**RE: Mercy Hospital – Final CO Phase 1
Follow-up including amendment re Service Area Access**

**RE: Mercy Hospital – Amendment to Approved Site Plan: Service Area Gate and Access Area
Vicinity of Fore River, Portland ME (201 Fore River Parkway)**

**Subject: Mercy Hospital – Fore River Site Project Amendment
 Service Area Gate and Metal Building Berm
 Summary of Meeting**

FIGURE
CSK-34

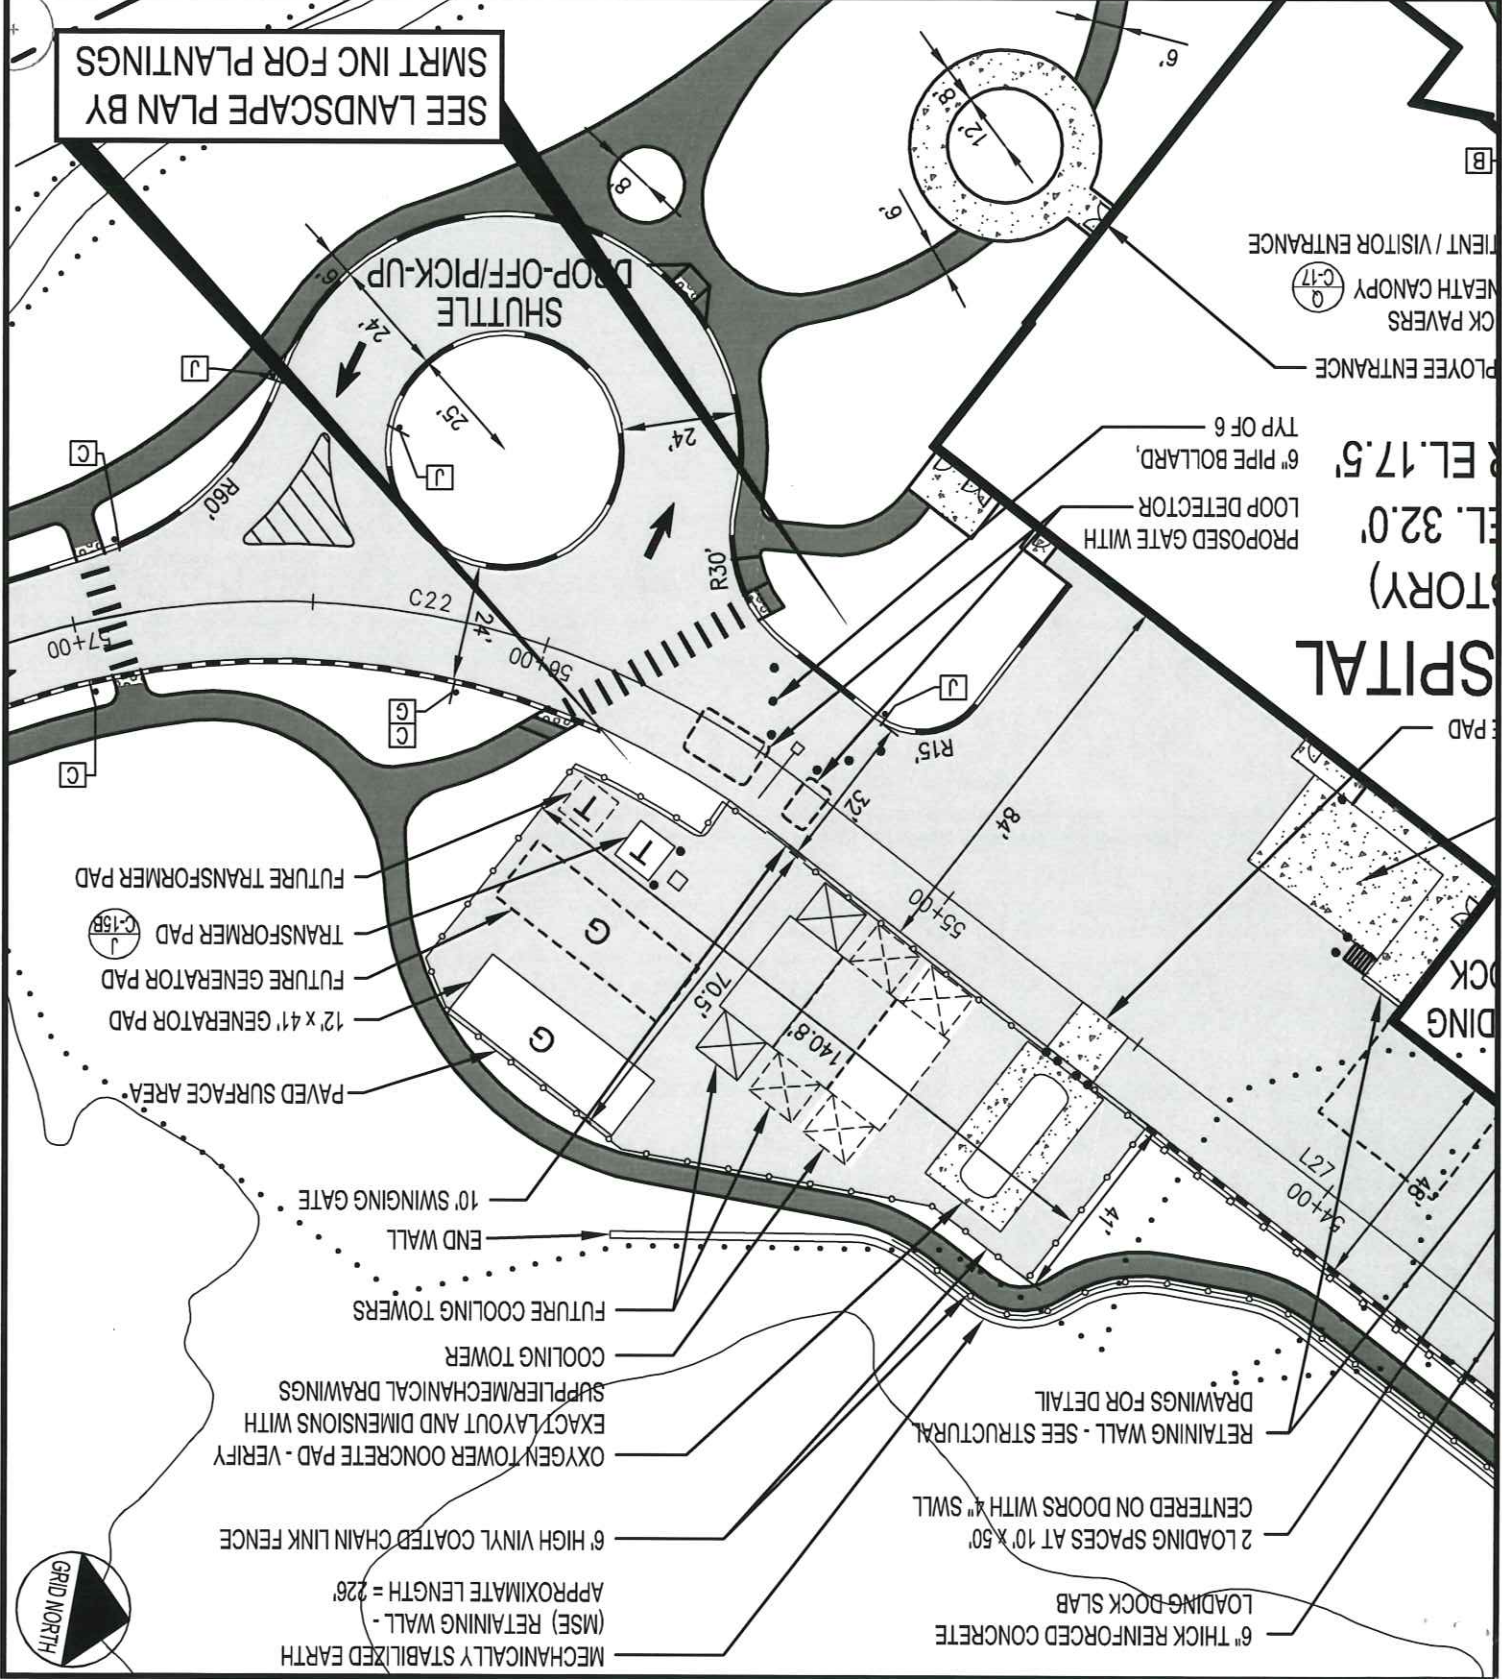
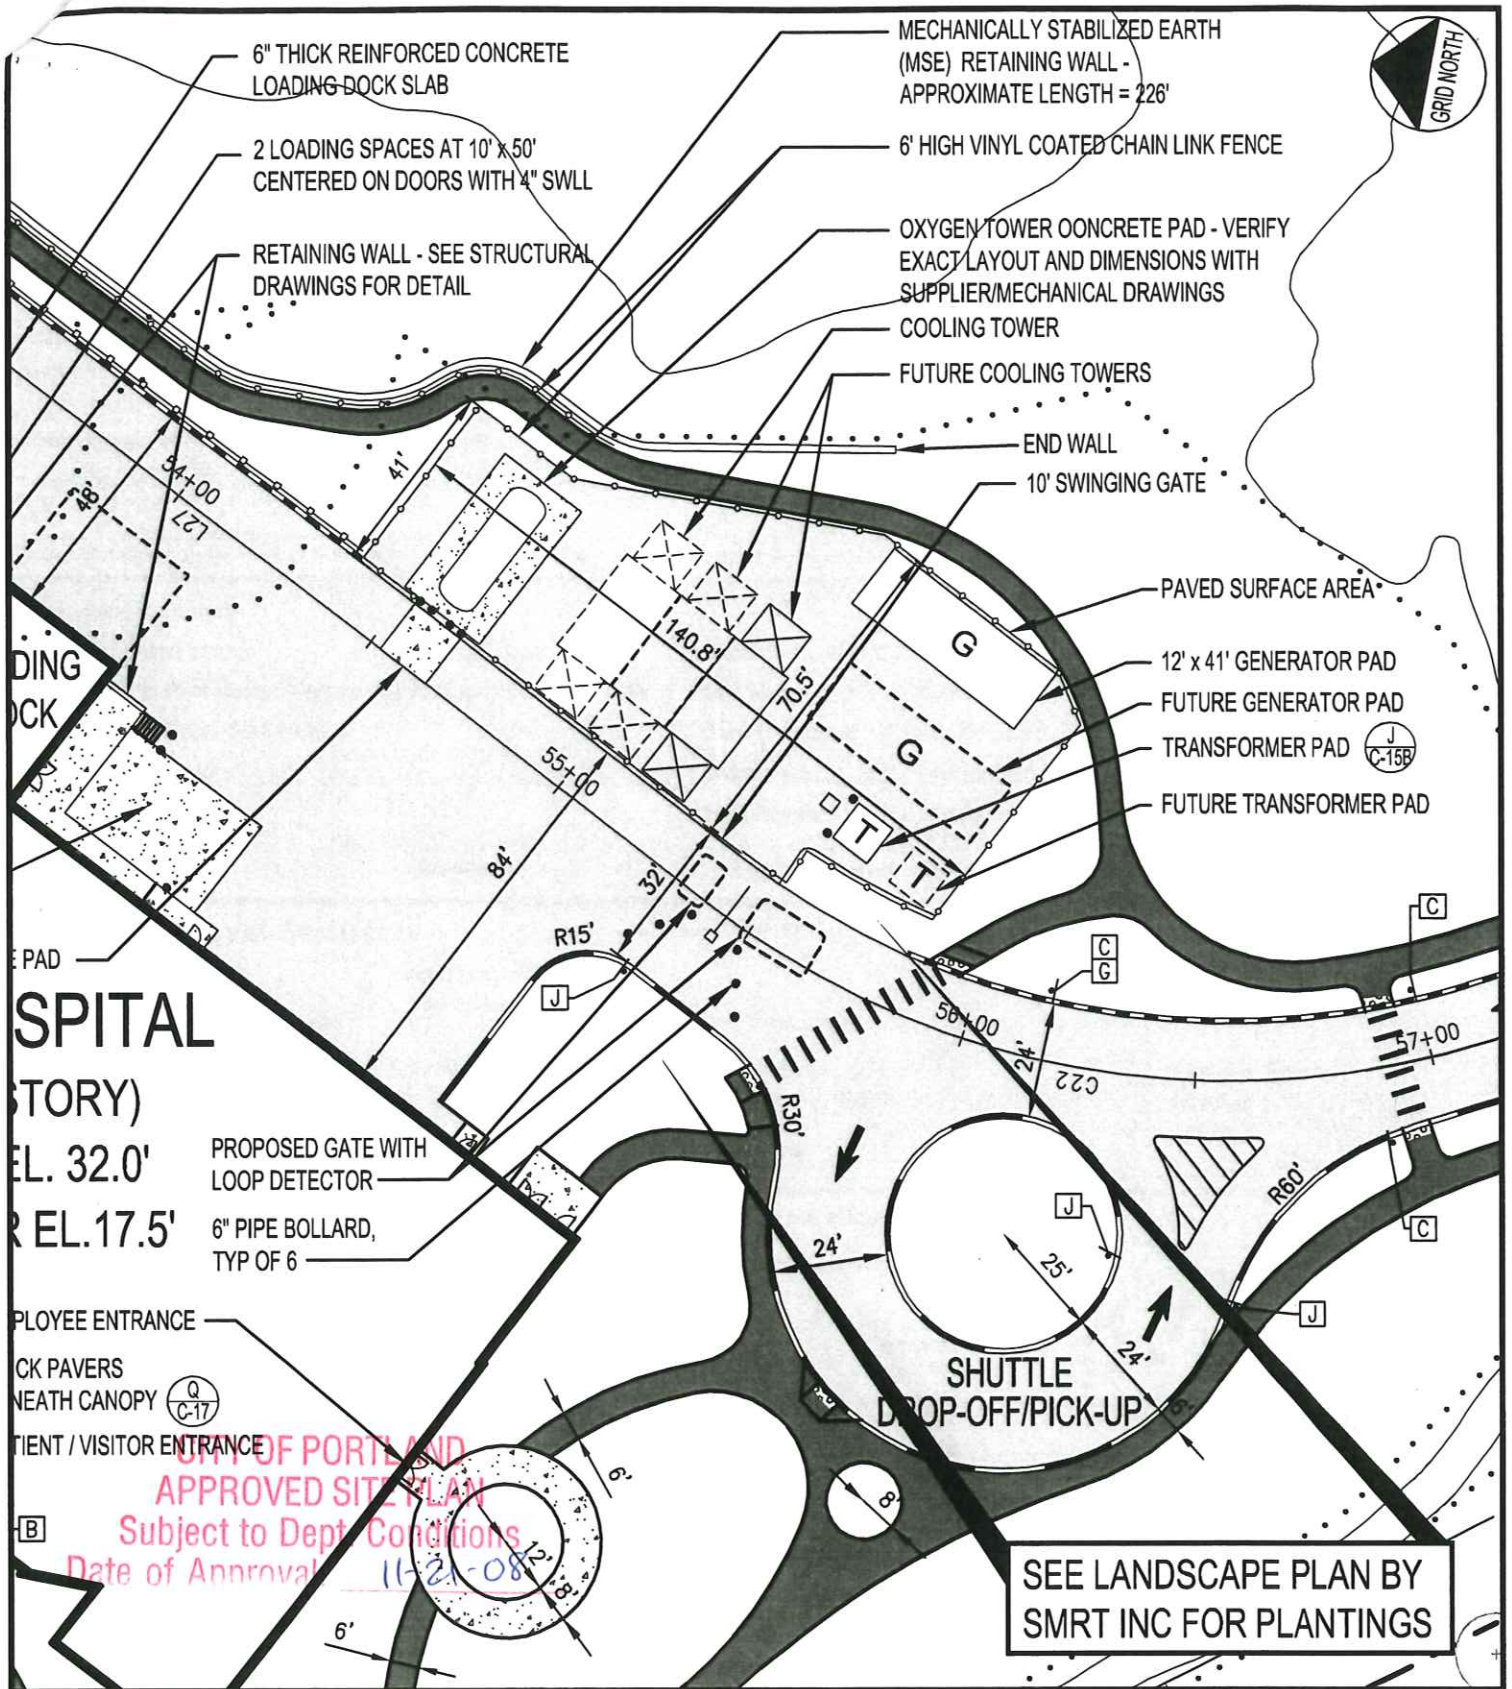
- STORY) EL. 32.0'
- EL. 17.5'
- PROPOSED GATE WITH LOOP DETECTOR
- 6" PIPE BOLLARD, TYP OF 6

CITY OF PORTLAND
 APPROVED SITE PLAN
 Subject to Dept. Conditions
 Date of Approval: 11-21-08
